Nomad

SERVICE BULLETIN

REDESIGNED CABLE CLAMPS FOR AUTOPILOT RUDDER SERVO BRIDLE CABLE (MODIFICATION N555)

Figure 1 Mod N555-Installation

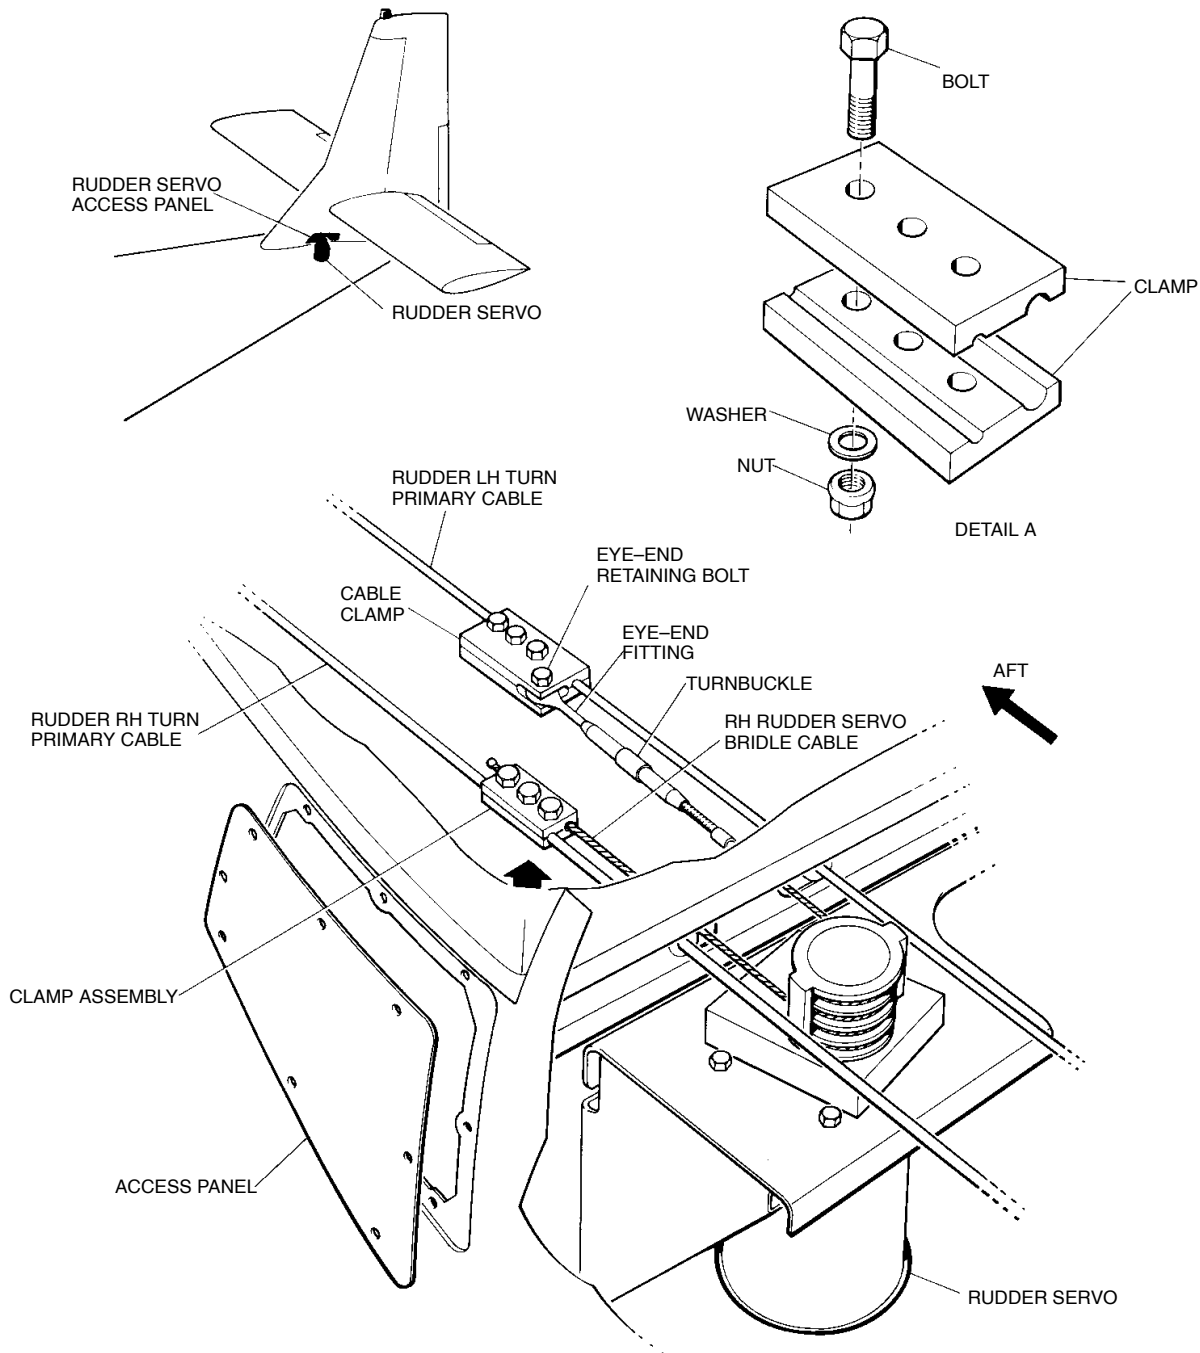
To improve the fatigue life of the autopilot bridle cable in the rudder autopilot control system.

The cable clamp assemblies which secure the autopilot bridle cable of the rudder control system are replaced by two more efficient type clamps.

- (8) Install the turnbuckle eye-end PN MS21254-2LS into the end of the turnbuckle from which the cable in step (7) was removed.
- (9) Loosely assemble the two clamps PN 1/N-45-1625 and 1/N-45-1626 onto the rudder LH turn primary cable and the eye-end of the turnbuckle using bolts PN AN3-6A, washers PN AN960PD10L and self-locking nuts PN MS21042-L3. Install the eye-end fitting retaining bolt PN AN3-6, washer P/N AN960PD10, castellated nut PN AN320-3 and split cotter pin PN MS24665-153.

- (10) Loosely assemble the two clamps PN 047-3536-01 to the rudder RH turn primary cable and the rudder RH turn bridle cable using bolts PN AN3-6A, washers PN AN960PD10L and self-locking nuts PN MS21042-L3.

- (11) Stretch the servo cables until taut without turning the rudder servo cable capstan. Ensure that each bridle cable is wrapped around the capstan approximately 2 (two) turns and seated correctly in the servo capstan grooves and that the cable clamps PN 1/N-45-1625 and 1/N-45-1626 are positioned on the rudder LH turn primary cable so that they will have 0.5 inch clearance from pulley bracket PN 1/N-12-264 (at Sta 451.35 (N22) or Sta 496.35 (N24)) when full right rudder is applied. Torque tighten the cable clamp nuts to between 20 and 25 lb in.

- (15) Remove rigging pins and rigging bar PN 1/N-88-60 and PN 1/N-88-80 installed in Para 2.A.(3).
- (16) Operate the rudder control through its full range and ensure no restrictions to movement exist. With rudder full right check that at least 0.5 inch clearance exists between the cable clamps PN 1/N-45-1625 and 1/N-45-1626 and the pulley bracket PN 1/N-12-264 at Sta 451.35 (N22) or Sta 496.35 (N24).
